ENGINE - LP TURBINE - INTRODUCE A REVISED STAGE 7 LPT AIR SEAL - CATEGORY CODE 7 -
MOD.ENG-72-0003

V2500-ENG-72-0003

SERVICE BULLETIN

View showing stage 7 airseal - Before and after alteration
Fig.1

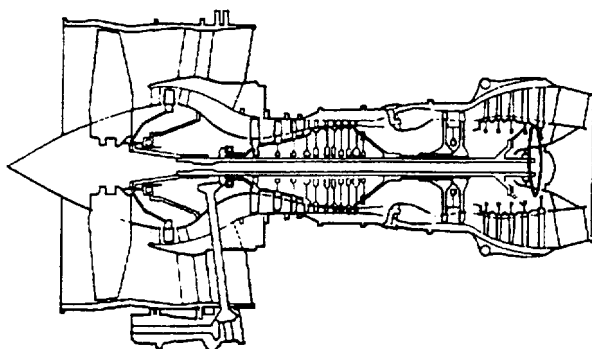
(a) The weight of the part is reduced by removal of the front lip and reduction of the aft shoulder diameter.

(b) The snap diameter of the airseal is reduced.

REMOVE P/N 3A0797
STAGE 7 AIRSEAL

INSTALL P/N 3A1741
STAGE 7 AIRSEAL

- (1) Install new 3A1741 stage 7 air seal on to the stage 7 Turbine disk by the approved procedure in Reference (2), Chapter/Section 72-50-30, Assembly-05 and figure 1 except:
 - (a) New air seal snap diameter: 19.1181 – 19.1221 inch (485,6 – 485,7 mm).
 - (b) Required new interference fit at location 3364: 0.0157 – 0.0236 inch (0,4 – 0,6 mm).
